Twyn Rivers DUA and Trails

Addendum #3

PROJECT TITLE:
TWYN RIVERS DAY-USE AREA AND TRAILS

DRAWING TITLE:
DAY-USE AREA LAYOUT PLAN

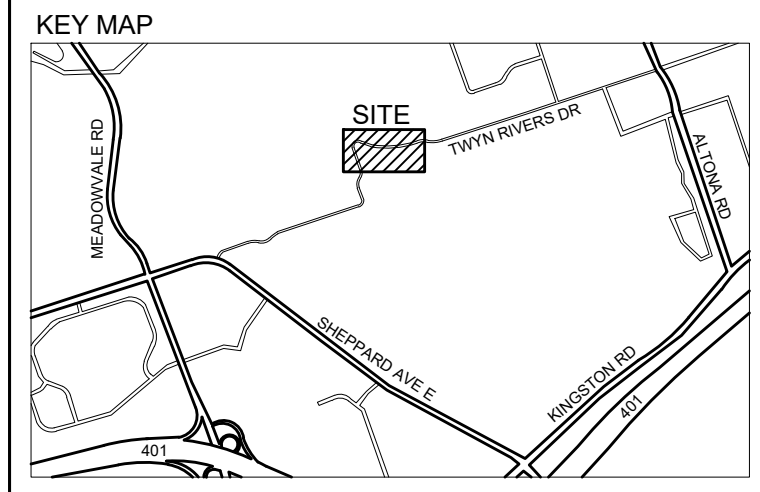
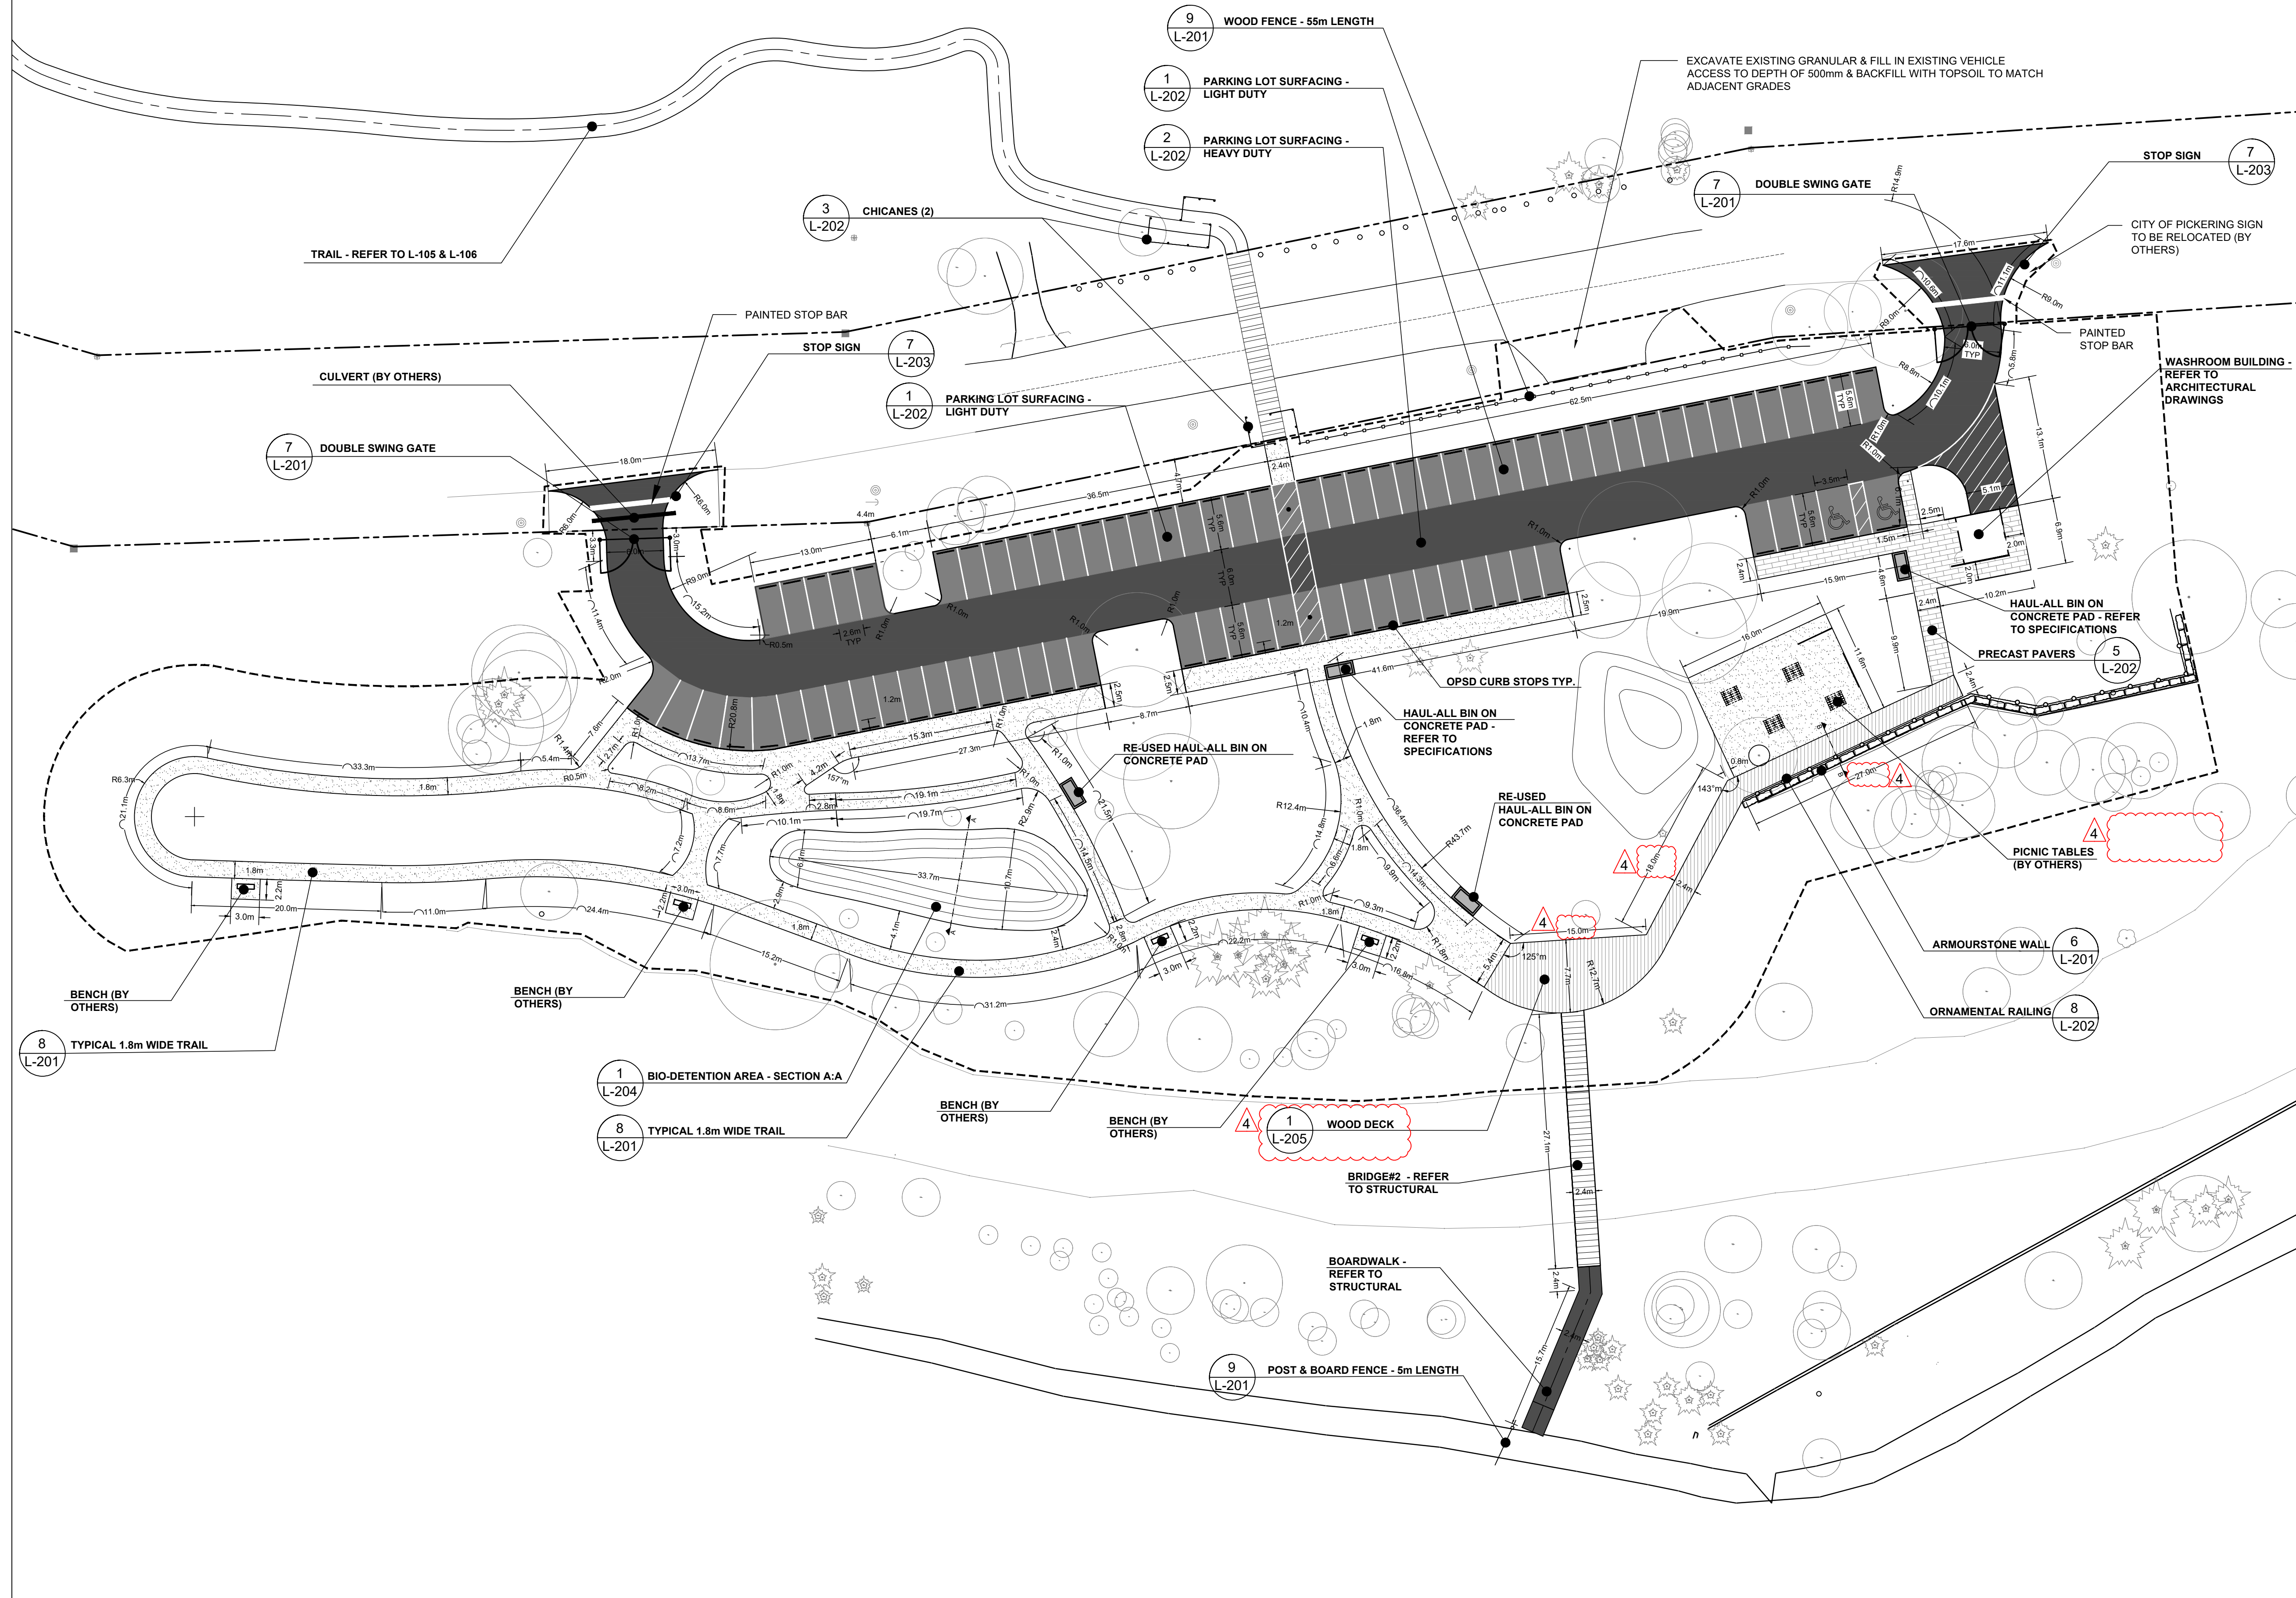
12) Can you please confirm the following:

- a. 1-bridge loading capacity?
- b. 2-the design to be by the contractor
- c. 3-White Cedar for all visible boardwalk, bridge and deck handrail components

- a. The bridge shall be designed in accordance with either OBC or CHBDC, which require 4 KPa loading.
- b. The contractor shall design the steel structure of the bridge matching the geometry that is provided in the contract drawings.
- c. 70 x 200 Rough Sawn Douglas Fir boards for bridge deck,
70 x 150 Rough Sawn Douglas Fir for Wood Deck,
70 x 150 Rough Sawn Douglas Fir for boardwalk decking, White Cedar for all other visible wood components of boardwalks

1
L-102

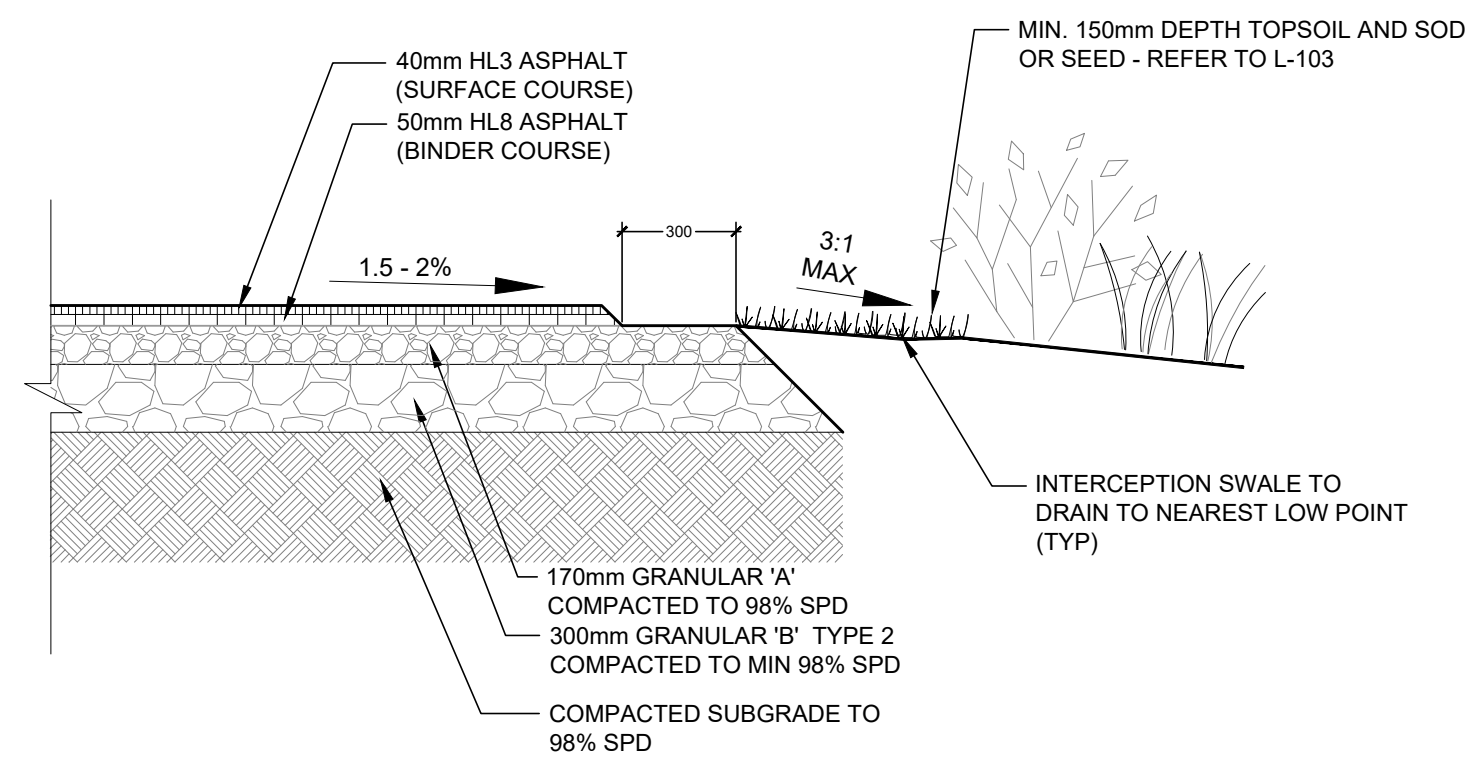
1a) Curbs to be installed as noted on L-102 are to be 2.4m length OPSD
